# Access Compliance Report

## Public Rights-of-Way

Intersection ID: 44419	Main Street: ARDREY_KELL_RD	Cross Street: PROVIDENCE_RD	Location: SE
ADA ID: A76548F112A6	Ramp Type: Perp	Initial Pass/Fail: Fail	Overall Compliance: No
Severity Score: 8.75			
Codes/Mitigation Info/Possible Solution		Field Measurements/Component Compliance

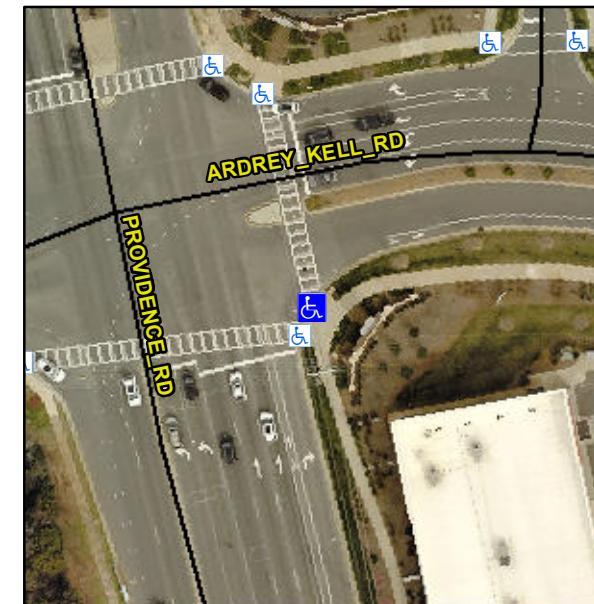
**Not Found, R304.5.1**

Compliance	Description	Data	Compliance	Description	Data
N/A	Ramp Length (in)	114.5	Yes	Ramp Slope (%)	7.7
No	Ramp Width (in)	47.5	Yes	Ramp XSlope (%)	1.6
N/A	Flare Type LT	N/A	N/A	Flare Type RT	N/A
N/A	Flare Slope LT (%)	N/A	N/A	Flare Slope RT (%)	N/A
N/A	Flare Traversable LT?	N/A	N/A	Flare Traversable RT?	N/A
N/A	Landing Length (in)	N/A	N/A	DWS Provided?	N/A
N/A	Landing Width (in)	N/A	N/A	DWS Contrast?	N/A
N/A	Landing Slope (%)	N/A	N/A	DWS Length (in)	N/A
N/A	Landing X Slope (%)	N/A	N/A	DWS Full Width?	N/A
N/A	Landing Curb? (Y/N)	N/A	N/A	DWS Offset (in)	N/A
N/A	Shared Landing?	N/A			
N/A	Gutter Ponding?	N/A	N/A	Gutter Slope (%)	N/A
N/A	Gutter Lip Ht (in)	N/A	N/A	Gutter X Slope (%)	N/A
N/A	Painted X Walk1?	Yes	N/A	Painted X Walk2?	N/A
	X Walk 1 Direction	To N		X Walk 2 Direction	N/A
N/A	X Walk 1 Width (in)	105.0	N/A	X Walk 2 Width (in)	N/A
	X Walk 1 Slope (%)	1.9		X Walk 2 Slope (%)	N/A
	X Walk 1 X Slope (%)	3.6		X Walk 2 X Slope (%)	N/A

**Remove & Replace Entire Ramp.**
